City of Portland Design Commission

Design Advice Request

SUMMARY MEMO

Date: December 10, 2021
To: Gary Golla, SERA Design and Architecture Inc.
From: Benjamin Nielsen, Design / Historic Review Team, BDS
(503) 865-6519, benjamin.nielsen@portlandoregon.gov
Re: EA 21-082922 DA – Choice Cambria Hotel
Design Advice Request Commission Summary Memo – October 21, 2021

Ground level design & programming

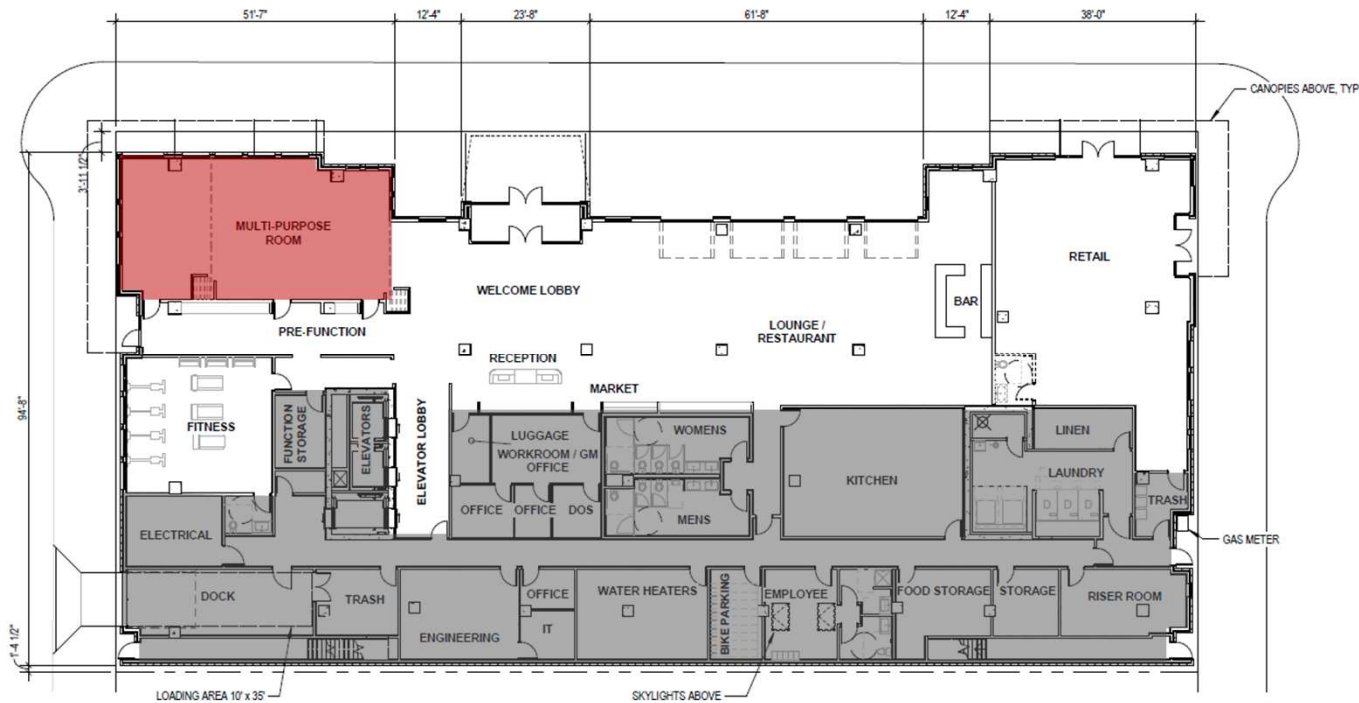
A multi-purpose room occupies the northeast corner of the site. It appears that it is possible to open this space up to the lobby, which may allow it to have more activity than it otherwise might as a simple meeting room space. It remains unclear, however, how much activation this program will provide.

Street trees

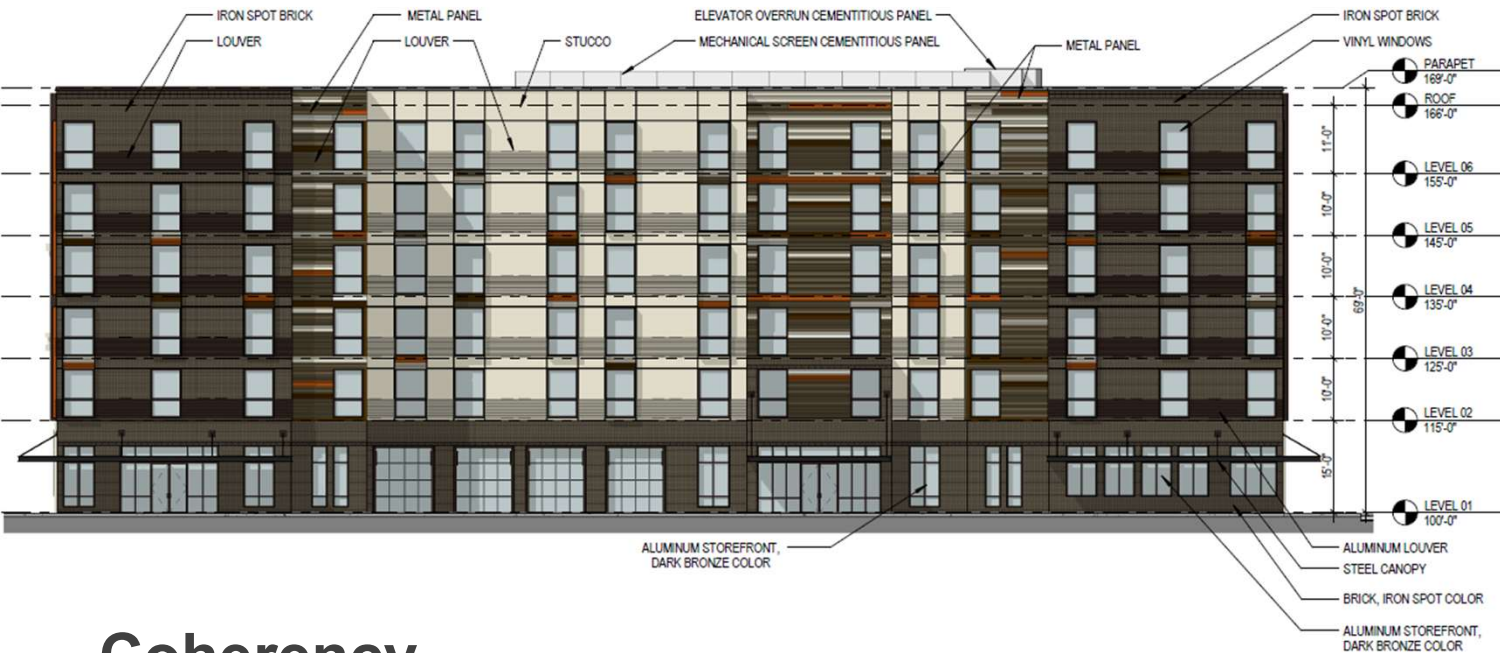
No street trees are indicated along NW Davis St. A large underground transformer may be interfering with tree placement there, but efforts should still be made to place trees in the planting strip on this street.

Additional trees should be placed in the planting strip along NW Park Ave as well. Staff believes that the provision of additional trees here is more important than centering the street trees on the building setback/courtyard area.
